CHAPTER 7
RESPONSE TO COMMENTS
DRAFT ENVIRONMENTAL
IMPACT REPORT

Antelope Valley Water Bank Project
(By Western Development and Storage, LLC)

Specific Plan Amendment No. 13, Map 232
Specific Plan Amendment No. 2, Map 233
Alteration of Boundaries of
Agricultural Preserve No. 24 – Inclusion

SCH#2005091117

Reference to Comment E

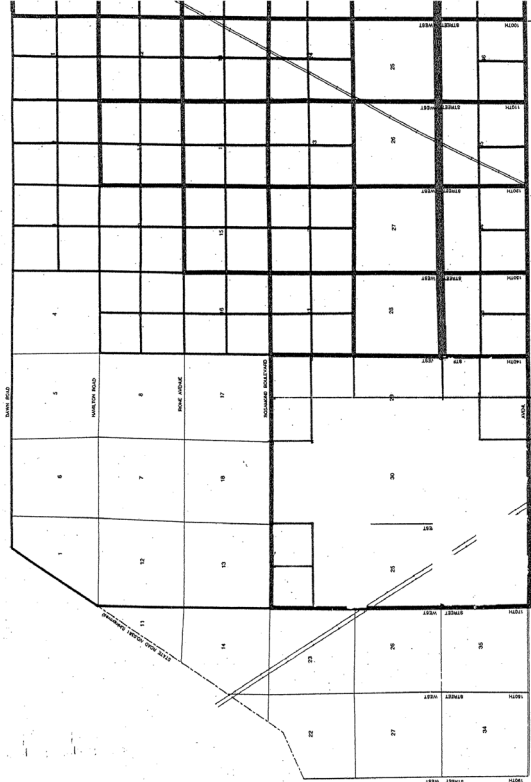
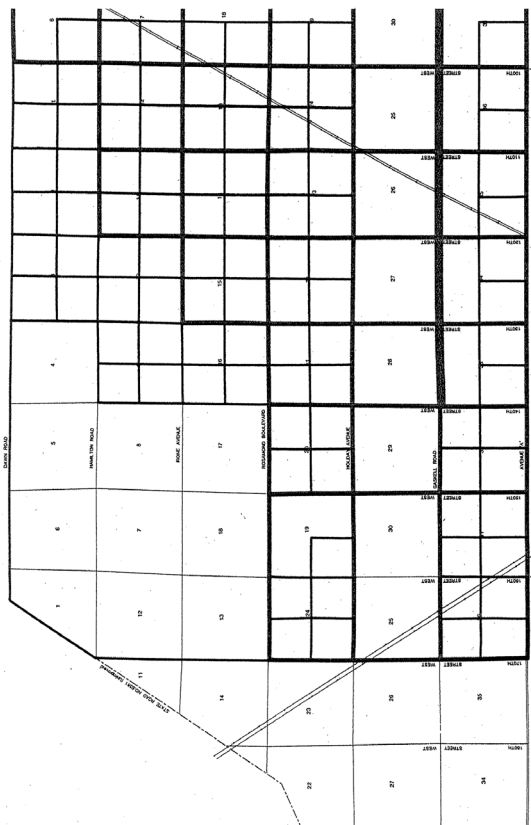
- Diversion of flood waters onto county maintained roadways shall be prohibited. Future proposals to construct berms, levees, or other facilities along the north boundary of any of the recharge basins shall demonstrate, through accepted study reviewed and approved by ESS, compliance with this flood water diversion prohibition.
- The Circulation element of the Willow Springs Specific Plan shall be amended as noted on the attached maps.

The comment recommends that the Circulation Element of the Willow Springs Specific Plan be amended as described on the maps. As noted above, impact to the County roads system is unlikely as a result of the constructed recharge basins. There are no roads currently present along the identified collector alignments such that the Project would affect a physical change in the environment associated with a road. Nonetheless, the project would not be consistent with the Circulation Element of the Willow Springs Specific Plan.

The third paragraph on page 1-2 is revised as follows:

- amendment of the WSSP to change various map code designations (Specific Plan Amendment No. 13, Map 232; and Specific Plan Amendment No. 2, Map 233);
- amendment of the Circulation Element of the WSSP to remove various collector alignments within areas proposed for recharge basins on 640 acres.
- inclusion of approximately 640 acres into Agricultural Preserve No. 24 (Agricultural Preserve No. 24—Inclusion);
- construction of wells, facilities, and accessory structures needed for ongoing maintenance and operation necessary to transport water; and
- authorization and permits from various affected agencies.
